RE: Culebra Creek II (Amended)

MDP # 792 - B

The City Staff Planning Review Committee has reviewed the Culebra Creek II Master Development Plan (MDP # 792-B). Please find enclosed a signed copy for your files. Your plan was accepted, however please note the following:

MASTER DEVELOPMENT PLAN
for
CULEBRA CREEK II 792-B

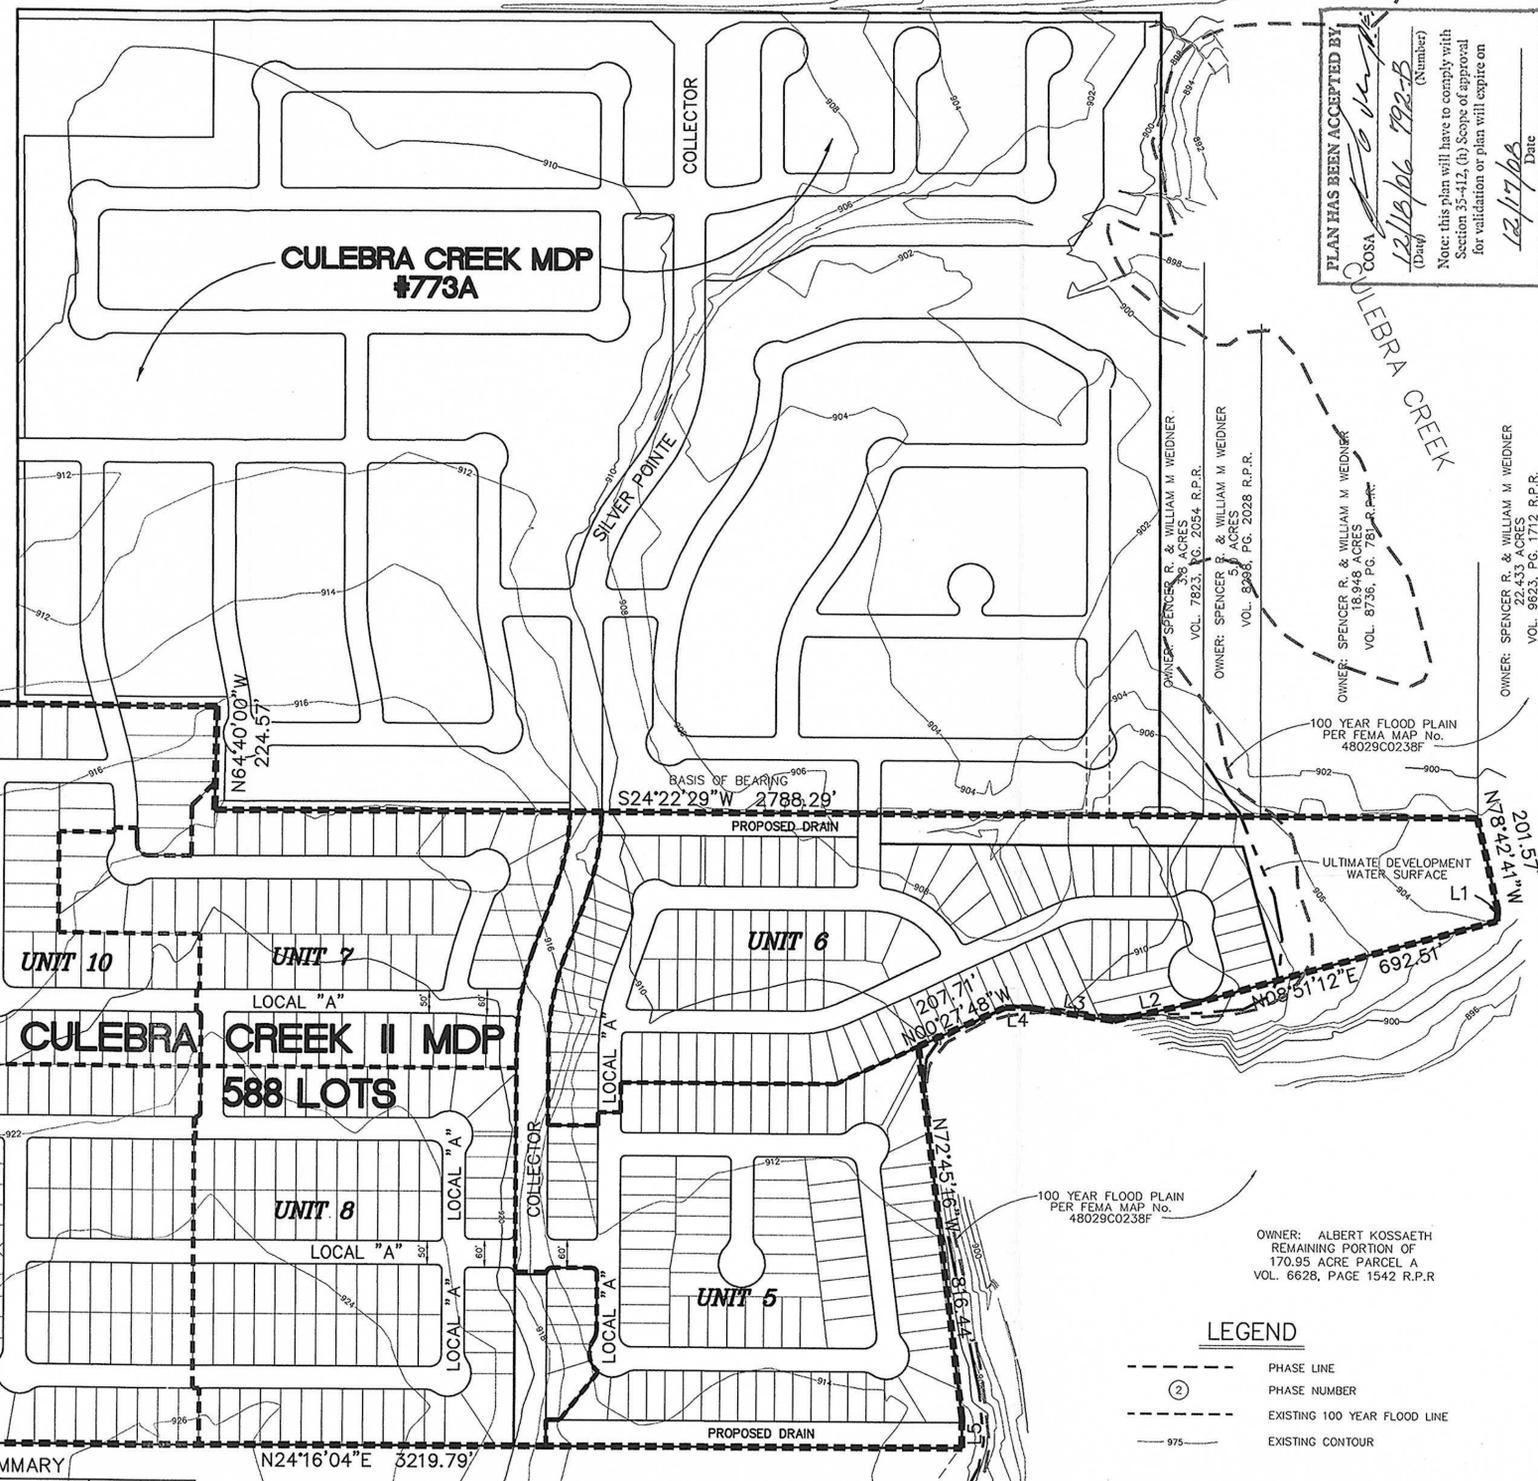
In consideration of public safety and convenience, excessive grades by reason of topography should be avoided in street layouts and arrangements.

The acceptance of this Master Development Plan is confined to the boundary limits of the site. Any projection(s) of future roadways outside the boundaries does not interfere with any set alignment of future roadways. All major arterials and streets shall follow all regulations.

Any access and ROW issues along state facilities will need to be resolved with the **Texas Department of Transportation (TX DOT)**. For information about these requirements you can contact TX DOT at 615-5814.

Historic Preservation requires an archaeological survey of the property as a condition of approval.

- All access driveways shall comply with UDC 35-506 (r).
- All sidewalks shall comply with UDC 35-506 (q).
- All access roadways shall provide clear sight distance on all existing and proposed roadways in order to provide adequate obstruction free viewing distances for approaching traffic. All signage, landscaping, and improvements shall be selected and located so as to not block these clear sight distance areas.
- It should be understood that this is a general review of a conceptual plan not in-depth review of internal and external traffic flow, nor streets and drainage plans. All technical requirements of the Unified Development Code (UDC) 35-506 will be complied with at the time of platting.

- It is understood that this MDP is a conceptual plan and all regulations will be addressed time of platting.
- Intersection sight distance should be used at all intersections.
- County reserves the right to address driveways, street design, sight distance, ADA requirements, and drainage and floodplain issues at time of platting.

It will be expected that you will plat all of the property depicted in your Master Development Plan (MDP) to include floodplains, drainage areas and open spaces.
